LANGENFELDER
12640 RT. 108
CLARKSVILLE

HOWARD COUNTY HEALTH DEPARTMENT

During the course of the recent septic repair inspection (repair approved, copy of inspection report enclosed), a well construction defect was observed.

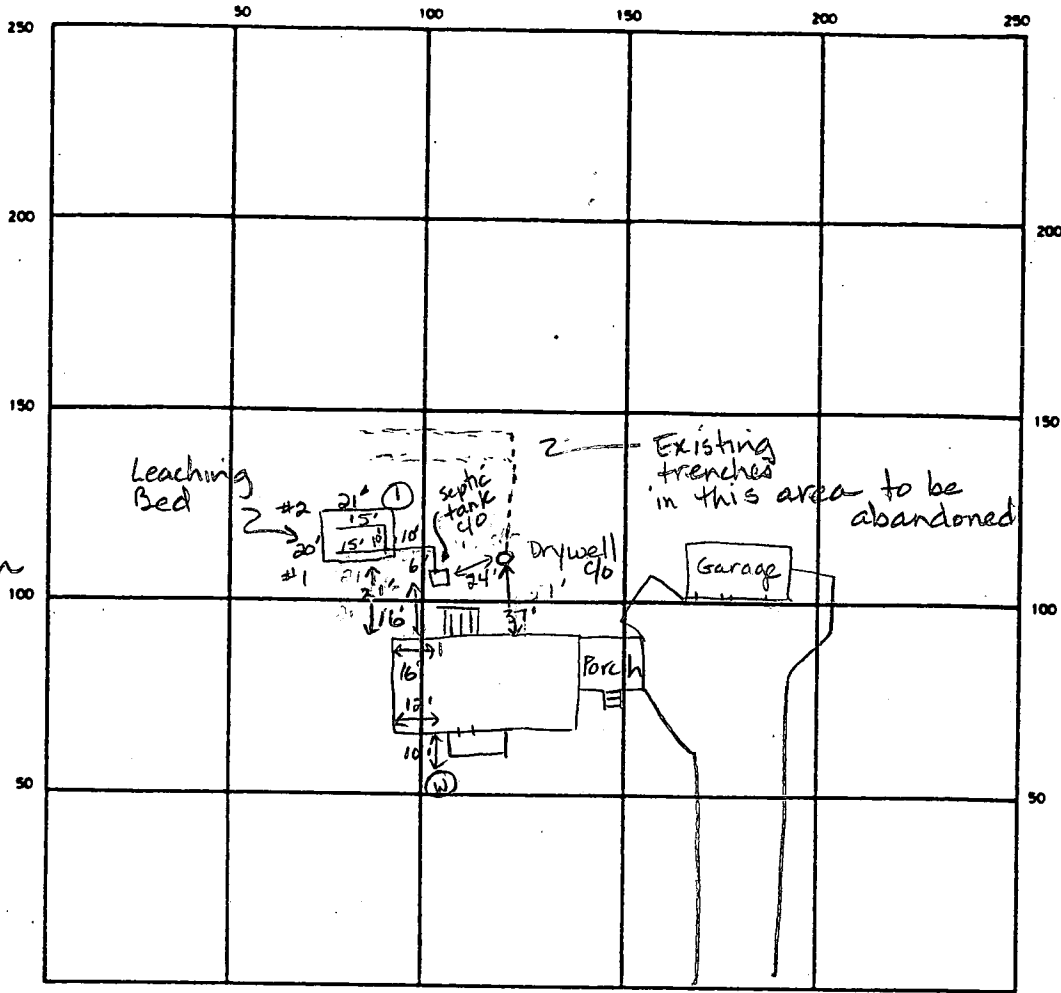
①
Test hole
water at
10.5 ft
5-9-90

5-9-90
Well cap
cracked, flush
w/ ground, open
to contamination
JEN

REMARKS 5-9-90 Leaching bed 6.5 ft deep at upper end, 4.5 ft deep at lower end. Existing drywell to be abandoned with leaching bed connected to existing septic tank. JEN 6-29-90 Contractor indicated depth to inlet is 2.5 ft from original grade and drywell had been abandoned. JEN

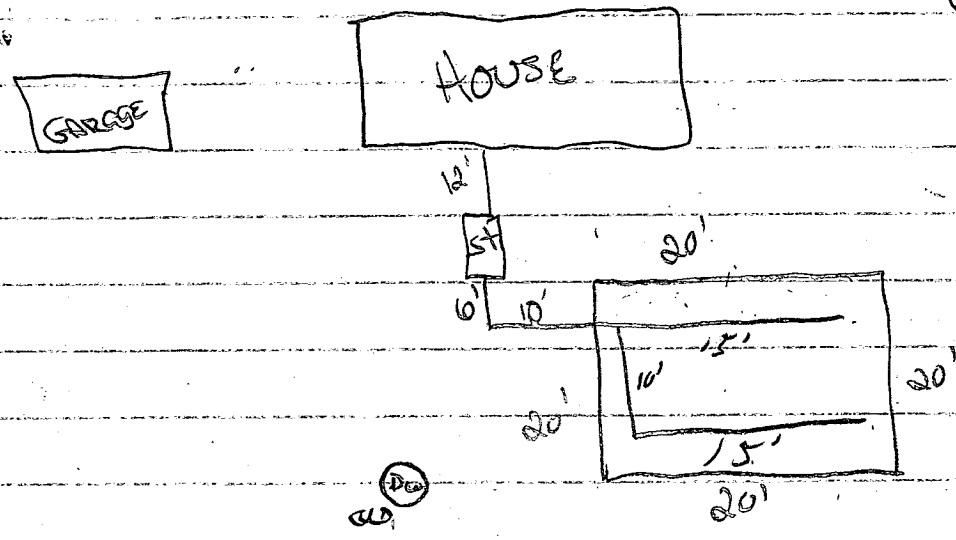
Depth to Inlet $2\frac{1}{2}$, to $5-5\frac{1}{2}$
